**Purchasing Department**

**Subject: Request for Quotes 2336-A: Lake Kedron Dam Intake Sluice Gate  
Addendum 5**

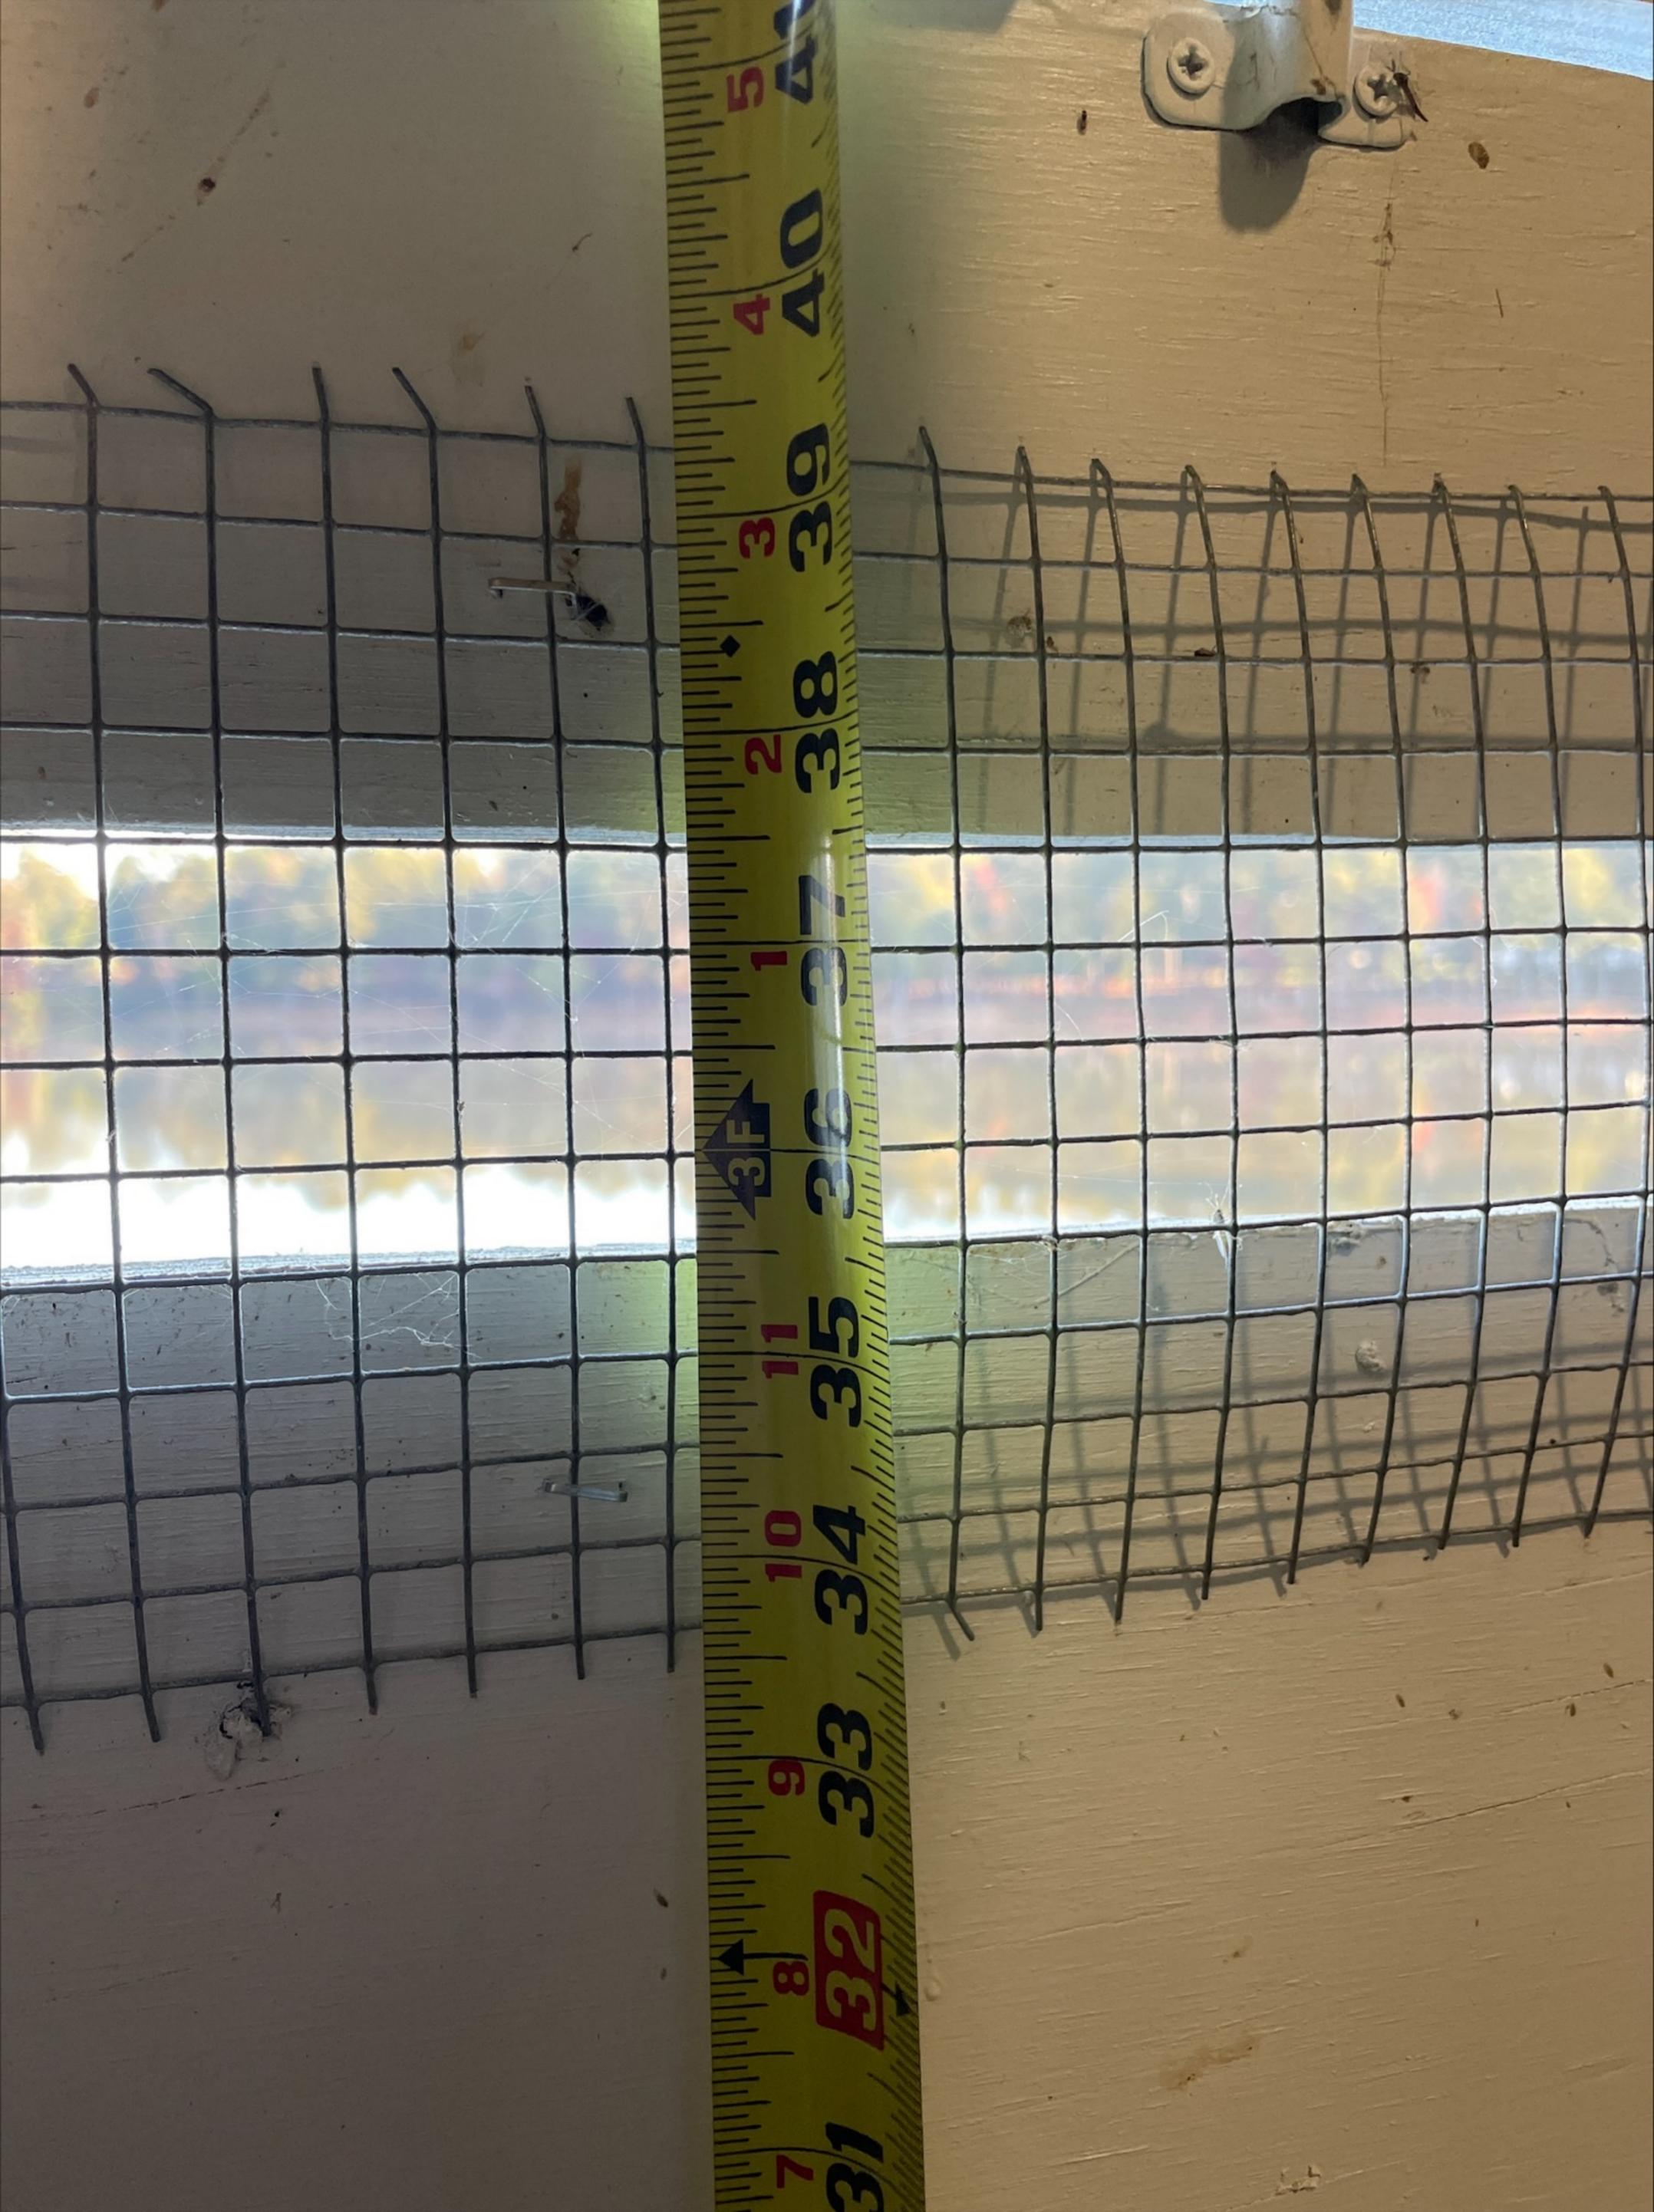
1. **Please provide the distance from the operating floor at the inside of the Intake Structure (where we were all standing on 11/2/23) to the centerline of the cutout where the handwheel will protrude.**  
36.5"
2. **Also provide the opening dimensions of the existing cutout (length x height).**  
25" x 2.25"
3. **Specifications part 2.1 specify leakage rate at 0.5 gpm per foot of seating perimeter. Can you confirm that is correct or is it meant to be 0.05 gpm?**  
It is as written - 0.5 gpm per foot of seating perimeter.
